Technical Analysis

Montalban Oil and Gas Operations Jody Field 34-2

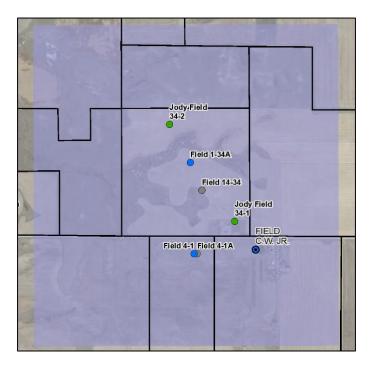
The EPA notes that the current 2010 aquifer exemption for the Jody Field 34-2 well only includes a 13 ft interval of the Madison Group and includes a 20 ft interval of the Sawtooth Formation (between 3,418 feet and 3,438 feet). In Attachment A, Figure 04 of the permit application, the interval between 3,418 feet and 3,438 feet is described as part of the Madison Group. After conducting additional research, the geology between 3,418 feet and 3,438 feet was later determined to be a dense calcareous transitional deposit which is part of the Upper Madison formation and not Sawtooth or a separate USDW.

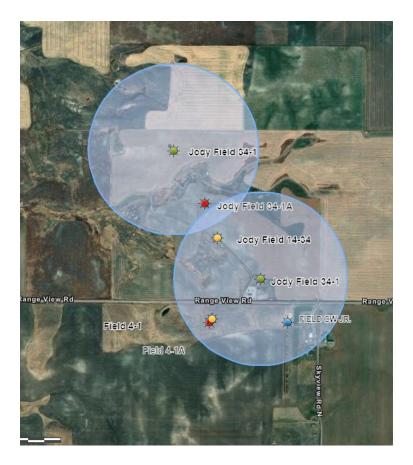
Jody Field 34-2 is completed open hole and the well shoe is set at the base of the Sawtooth formation directly above the Sun River Dolomite. The Sawtooth formation is dense and does not produce in this area or take water. Well logs provided in the UIC application for wells Jody Field 4-1 and Jody Field 4-1A indicate that the bottom of the Sawtooth formation is hard and dense with no oil shows. Research included a review of well logs in the area and review of the USGS Produced Water Database V2.3 across the Sweetgrass Basin in Montana. The USGS Produced Water Database indicates that there are 69 oil and gas wells producing from the Sawtooth Formation within the basin. One of the 69 wells is identified as Jurassic, 9 wells are identified as Devonian and the remaining 59 wells are identified as Mississippian (Madison Group or Lodgepole). The two wells located within Pondera County indicate specifically that the Sawtooth Formation is part of the Madison Sun River Dolomite, further suggesting that this zone between 3,418 feet and 3,438 feet is transitional within the Upper Madison and not a separate USDW.
